Report to Norwich highways agency committee

23 October 2014

Report of Head of city development services

Subject Push the Pedalways – Tombland and Palace Street

Appendix 1 – Tombland & Palace Street proposals

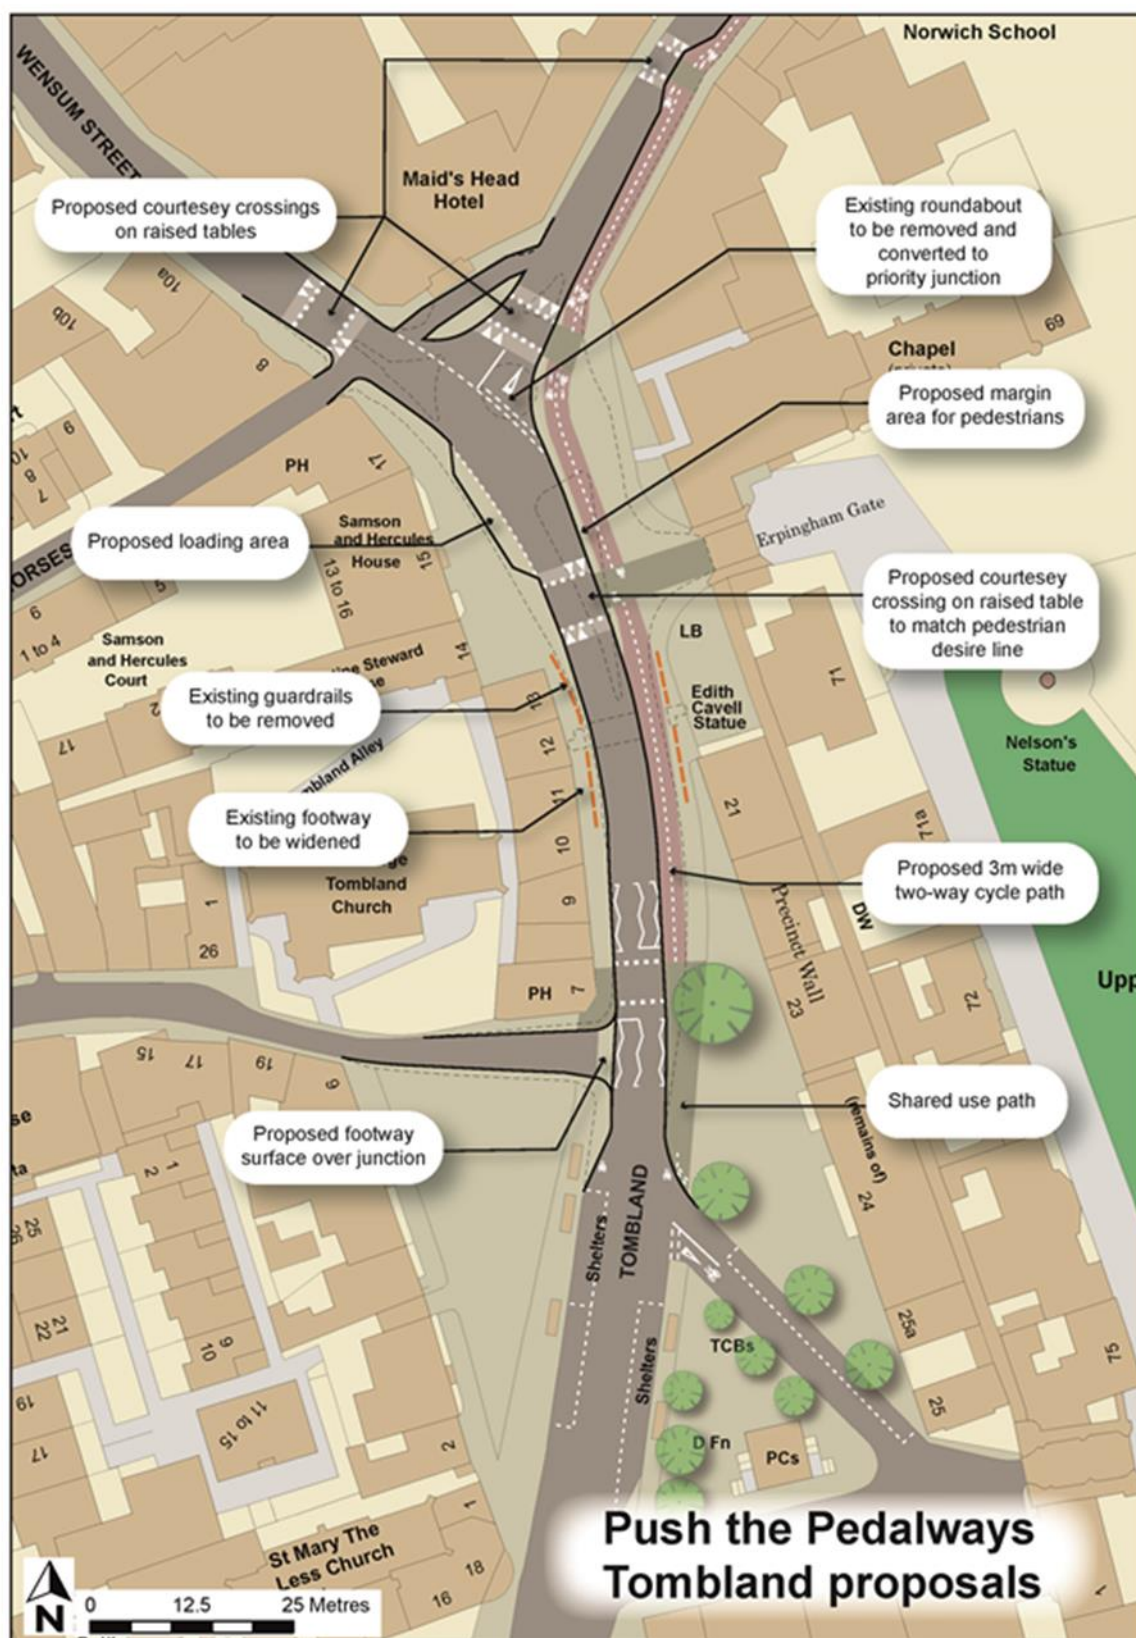
1. At the NHAC meeting on 12 June 2014 the committee agreed in principle the proposals for Tombland and Palace Street, as shown on the plans attached in Appendix 1.

Appendix 3a – Tombland revised proposals

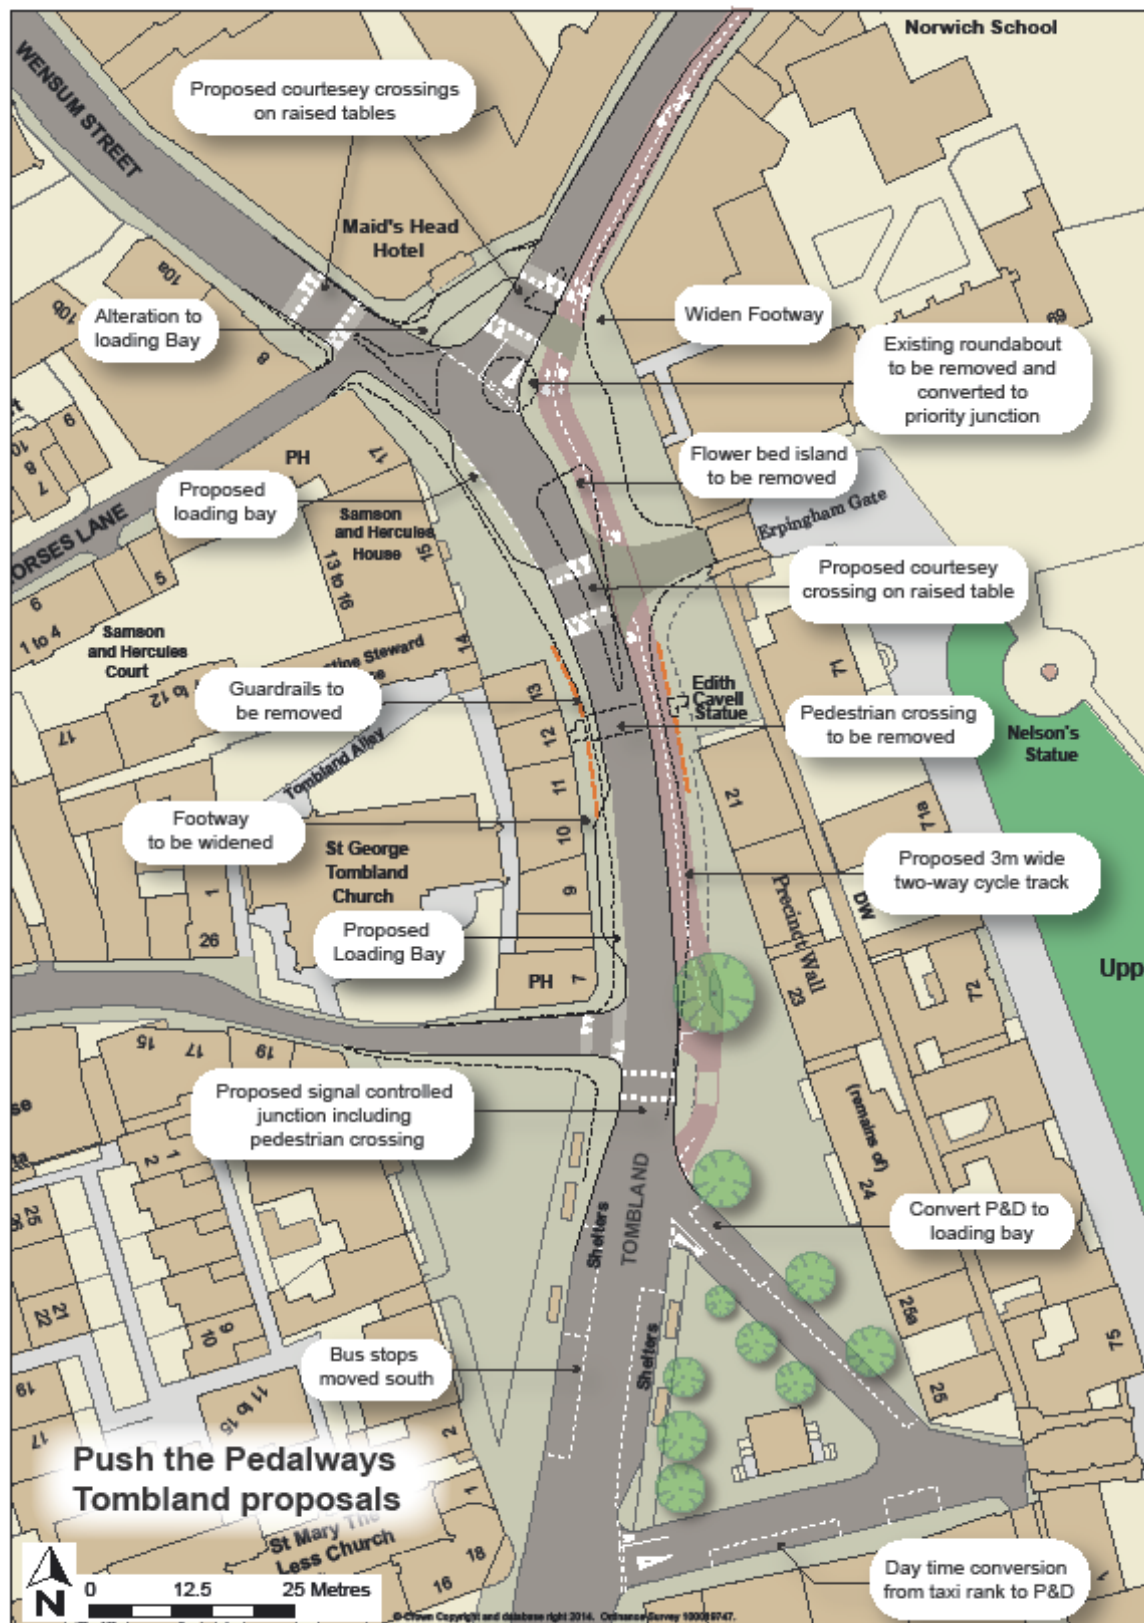
- (1) Notes the results of the consultation on the proposed plans for Tombland and Palace Street
- (2) Agrees the following modifications to the plans, which respond to some of the objections raised through the consultation:

- (a) Introducing traffic light control at the junction of Princes Street and Tombland, with a pedestrian crossing on Tombland immediately to the south of the junction

- (b) Introducing an additional loading bay outside 7-11 Tombland and on the north-south arm of the “Tombland triangle”
 - (c) Omitting the proposed pinch point / raised table crossing on Palace Street immediately south of the junction with Pigg Lane.

8. The existing crossing is also not compatible with the proposed cycle track on the east side of Tombland. The proposed toucan crossing by Princes Street, which in the consultation version of the plan would have been shared by cyclists and pedestrians, has been replaced by a signal controlled junction for cyclists and vehicles with a separate pedestrian crossing. This is a response to concerns that were raised about potential conflict between waiting pedestrians and cyclists using the cycle track. Providing a formal crossing at this point, centrally in Tombland, links with more of the pedestrian and cyclist crossing desire lines than at any other point.

9. The provision of this new junction does have the potential to limit the flow of traffic on Tombland during peak hours (and in particular the evening peak) which could lead to increases in congestion. To avoid this, the lights will be on a longer phase at peak time so that sufficient time is given to movements on Tombland at the expense of a longer wait to cross Tombland from Princes Street. In the longer term, the implementation of other changes in the city centre will reduce traffic levels here, allowing crossing times to be reduced without needing to redesign the junction again.

Ask the Head of Development services to progress the detailed design of the modified plans shown in appendix 3 for implementation in 2015.
